## **8.16. Kirribilli to Cremorne, Walking Cycling and Streetscape Upgrades**

This report provides detail of outcomes of consultation on the proposed Kirribilli to Cremorne Walking, Cycling, and Streetscape Upgrades project.

## Kirribilli to Cremorne Cycling and Streetscape Upgrade - Submissions Summary (prepared June 2021)

Sheet 3 of 5

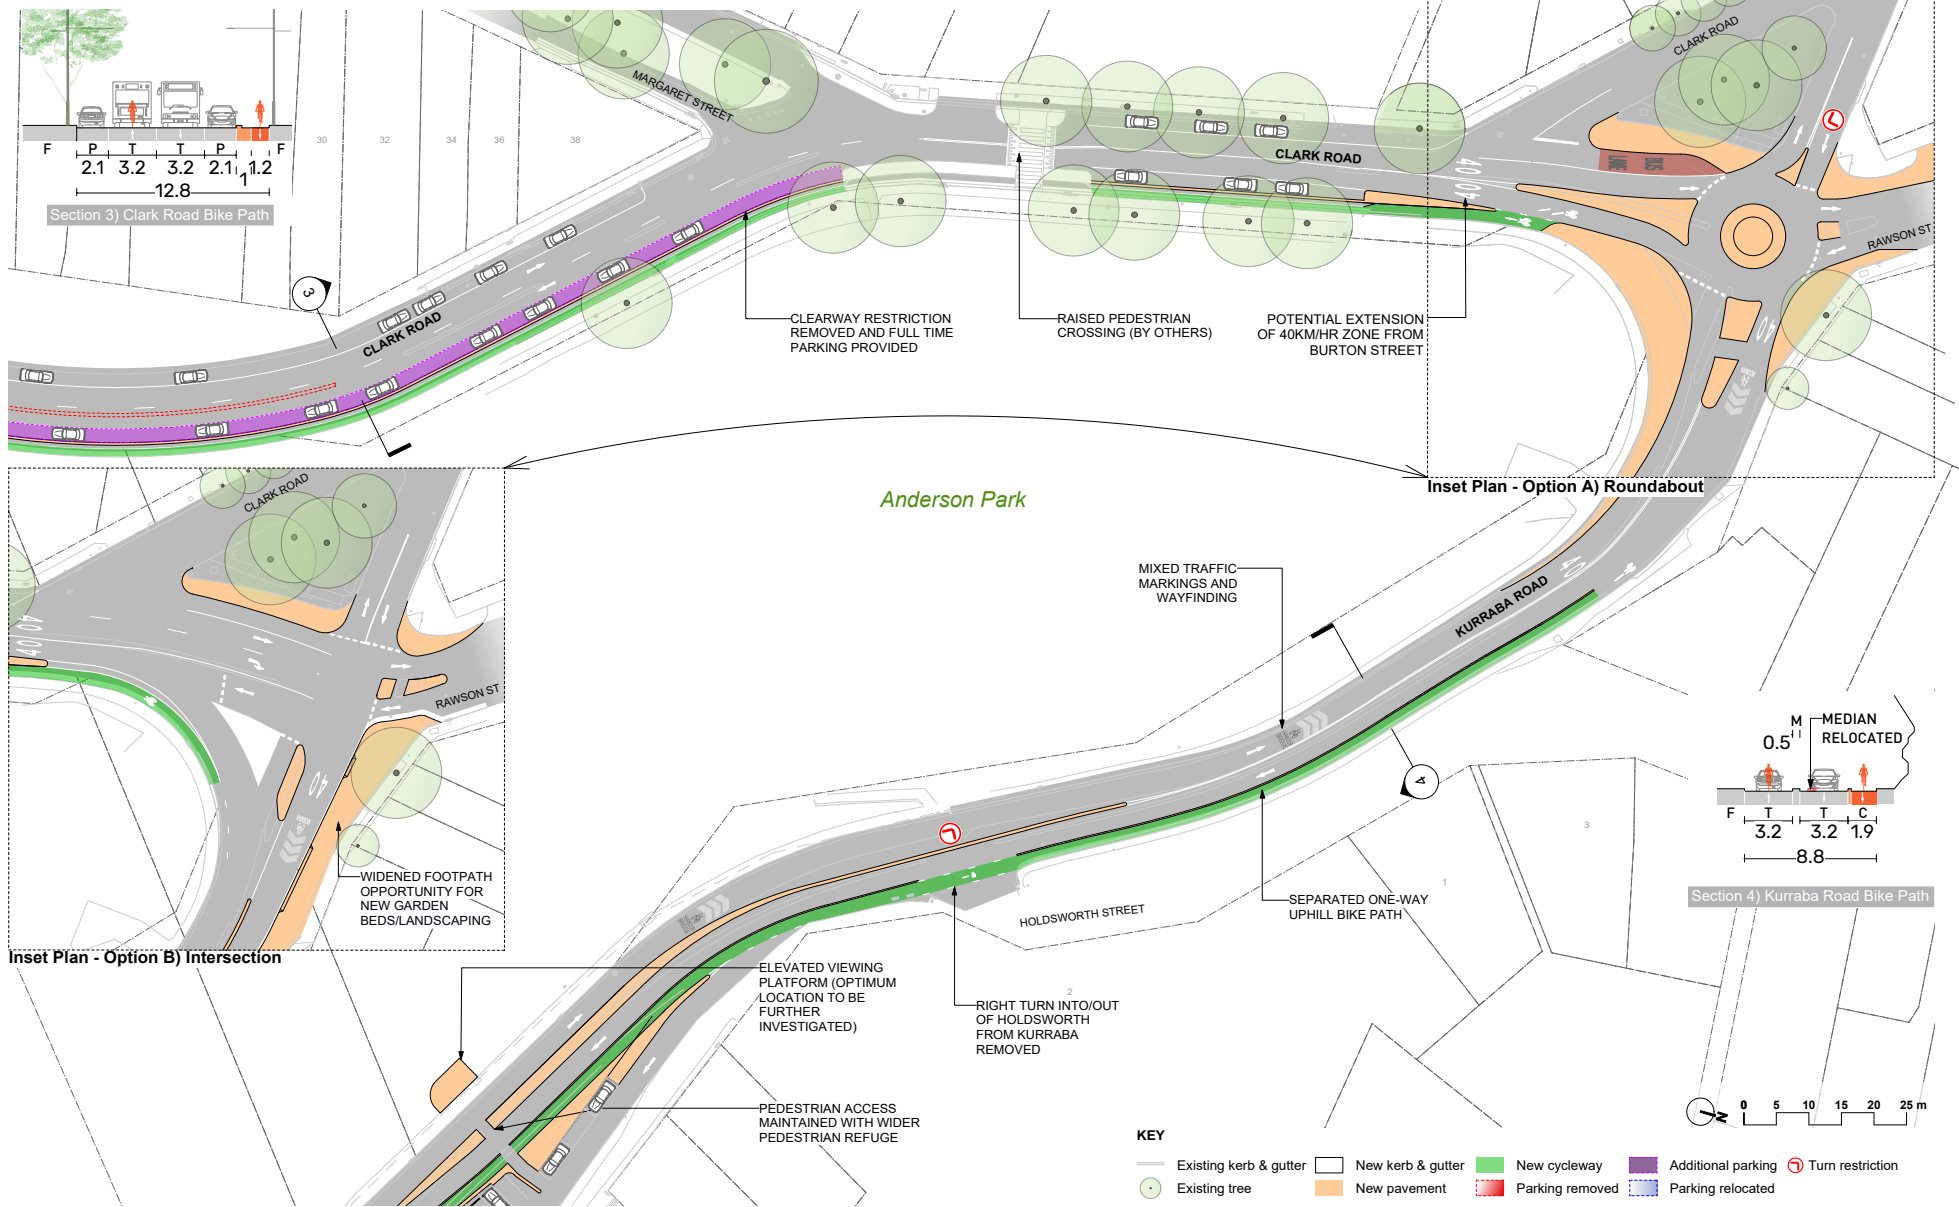
64	Anonymous	<p>I refer to [attached] Sheet 3 of 5 - Clark Road</p> <p>A. Do Not proceed with the proposal to remove the week-day mornings peak hour clearway restriction and have full time parking on Clark Road (between Margaret Street to Adderstone Avenue). This results in 2-lanes becoming 1-lane in that area.</p> <p>Observations:</p> <ul style="list-style-type: none"> <li>• Clark Road/Kurraba Road is an arterial road to/from SHB and North Sydney area. Likewise, in the opposite direction, to/from Neutral Bay and suburbs Cremorne to Mosman.</li> <li>• It is common in the week-day peak hours mornings and some week-day peak hours afternoons, for traffic on Clark Road to be banked-back from High Street to beyond Margaret Street, and sometimes past Rawson Street and up Kurraba Road.</li> <li>• This congestion is caused by traffic wishing to turn right in to High Street and up to North Sydney or to the Sydney Harbour Bridge.</li> </ul> <p>With retaining the week-day mornings peak hour clearway restriction there will remain 2 lanes in the morning whereby:</p> <ul style="list-style-type: none"> <li>• Buses can continue to move along the left lane to the bus stop just before High Street and then cut across the traffic into the right lane and up High Street to North Sydney or to the Sydney Harbour Bridge.</li> <li>• Traffic wishing to go straight-on to Kirribilli is able to proceed straight ahead without being held-up for the flow that is turning right into High Street.</li> <li>• Emergency vehicles (Fire, Police, Ambulance) are not prevented from proceeding along a proposed 1-lane road that is notoriously held-up at the High Street traffic lights during the week-day mornings peak hours</li> </ul> <p>The table summary "Anticipated Improvements on Clark Road (High Street to Kurraba Road) claims the proposals will result in reduced queue lengths/wait times at the intersection of Clark Road and High Street". <u>This is impossible</u>. In fact, <u>traffic congestion will become much worse</u>.</p>	A

- AM Clearway restrictions/congestion - Network modelling indicates that the clearways are not needed for network capacity reasons if improvements are made to the intersection of Clark Road and High Street – allowing the current restrictions on parking to be removed and opening up 31 new parking spaces in the am peak. Modelling of the intersection performance indicates that the intersection will have sufficient capacity to operate within a range typical of the network. The proposed changes would likely improve intersection queueing/wait times. This change would be subject to TfNSW approval.  
Note: some respondents interpreted the removal of clearway conditions to mean that a lane would be removed from Clark Road. **This is not the case.** Both lanes would remain albeit narrower than existing.
